PLAINTIFF'S EXHIBIT
JM 679

A [illegible] CURRATE PENDING REV TO DWG PE16-100

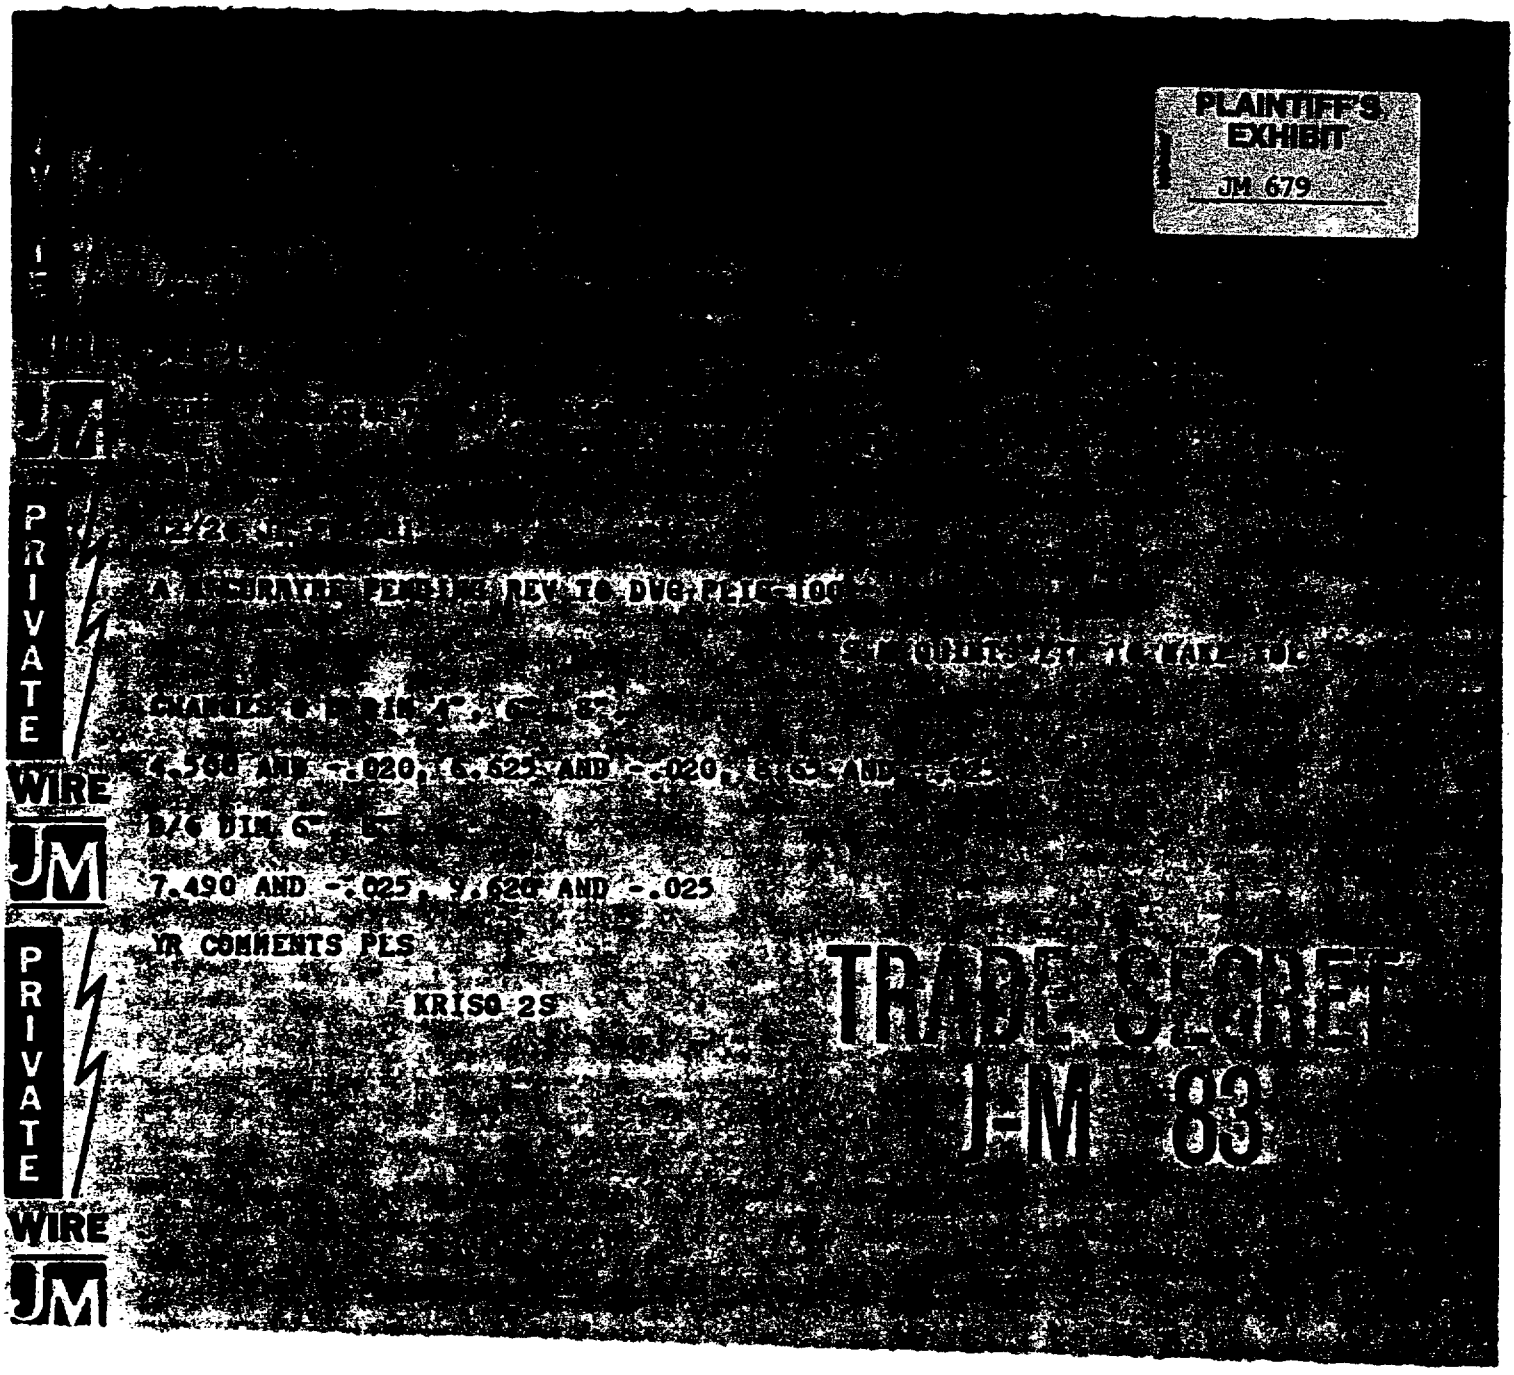
CHANGES [illegible] DIM 4", 6", 8"

4.500 AND -.020, 6.625 AND -.020, 8.65 AND -.025

D/6 DIM 6", 8"

7.490 AND -.025, 9.620 AND -.025

YR COMMENTS PLS
